TECHNICAL BULLETIN

UPS2613-2bNAS2

Update Prior to Sale: Charge Air Cooler Clip / Hose Inspection

XF (X250) 2.0L GTDi engine only

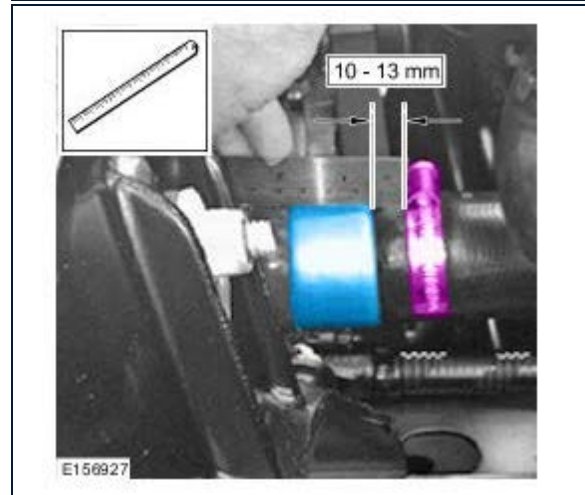
1. Open the vehicle hood.
2. Locate the Charge Air Cooler hose-to-resonator connection.

3. Check the position of the Charge Air Cooler hose clip:
 - If the clip is less than 10mm from the resonator, a gap exists between the resonator and the end of the hose, or the clip is not positioned squarely on the hose, continue to step 4.
 - If the clip is between 10mm and 13mm from the edge of the resonator and the hose is butted against the resonator, continue to step 6.

4. For any clips or hose found to be in the incorrect position, raise an EPQR, attach a photograph of the clip or hose with a ruler next to it so that the out of position measurement can be estimated from the photograph, and submit the EPQR with a reference in the description to this UPS.
5. Reposition hose correctly on the resonator and position the clip 13mm from the edge of the resonator.
6. Tighten the clip to 6Nm, ensuring the clip remains in position and square to the edge of the resonator.
7. Close the vehicle hood.
